Access Compliance Report Public Rights-of-Way (Curb Ramps)

Main Street: **KATELLA_AVE** Cross Street: **N/A** Location: **SE**

ADA ID: **RPRK210920124019** Ramp Type: **Type 1 - Perpendicular Diagonal Initial Pass/Fail: Fail** Overall Compliance: **No** Severity Score: **15**

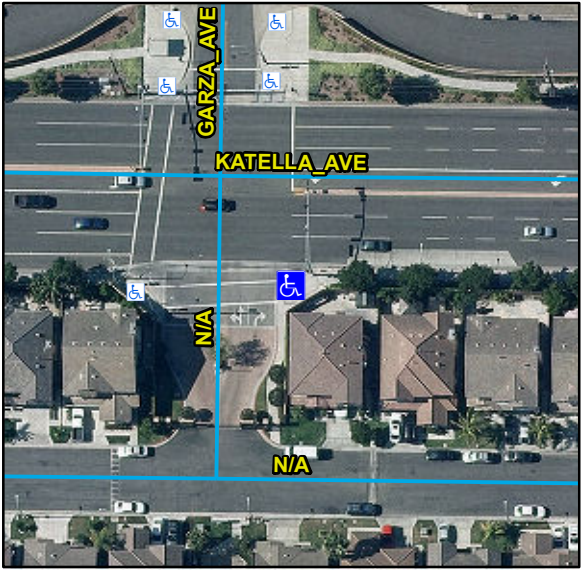
OC Std/PROW:
R304.2.2, R304.5.3, STD 1115

Possible Solutions:
Remove & Replace Curb Ramp With Two New Directional Ramps or Equivalent.
